# North West Growth Centre water related services for first release precincts

Modification Assessment Report

**RESPONSE TO SUBMISSIONS**

July 2012

Figure 1-1 Location of additional drinking water and wastewater infrastructure – ‘the Modification Proposal’

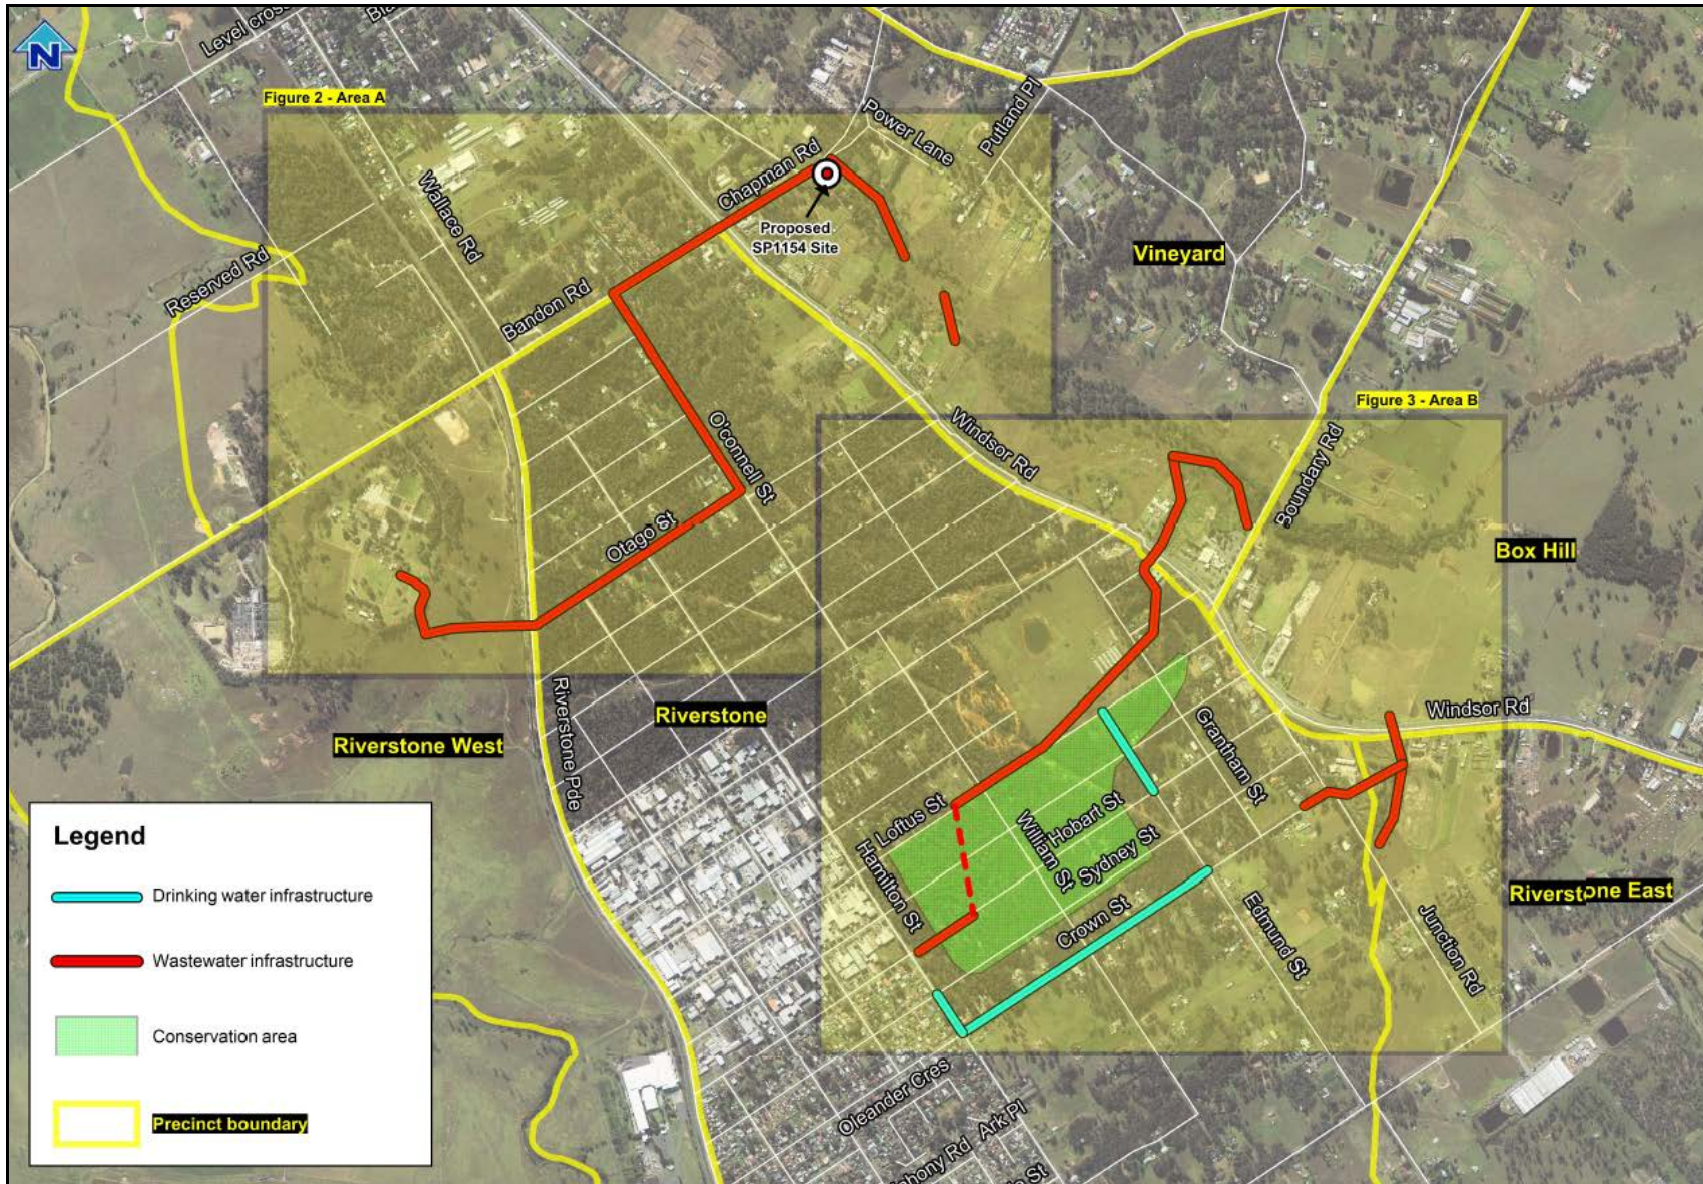
3. Clarify whether all infrastructure shown on Figure 1 has been assessed, if not recommend additional survey as there is non-certified ENV and given the number of records of threatened species and endangered ecological communities in the study area.

Figure 1 in the Modification Assessment Report shows all infrastructure associated with modified scope of works. All pipelines have been assessed. Some of these pipelines were assessed in the

original EA, and therefore have not been assessed again in the Modification Assessment report. This included the section of Rising Main 3 along Bandon Rd and Chapman Rd as it formed part of one of the rising main alignment options from the original SP1154 site location. This section of pipeline does traverse certified and non-certified land, however no vegetation impacts were recorded in the 2007 flora and fauna assessment as it is to be built in the road corridor.

Crown St and Hamilton St drinking water pipelines were assessed in the MAR (Appendix D - Ecological Impact Assessment (see Figure D.3 and Table E.6). They were not shown on Figures 4 and 5 of the MAR, taken from the Ecological Impact Assessment report as these were additional lines assessed. However they do form part of this Modification proposal as described in Table 1 of the MAR. Sydney Water has updated Table 4 from the MAR, see Table 3-1 below, to include these drinking water pipelines as a line item. The Crown St and Hamilton St pipelines do not result in clearing of any non-certified ENV, and therefore do not impact the amount of ENV to be offset.
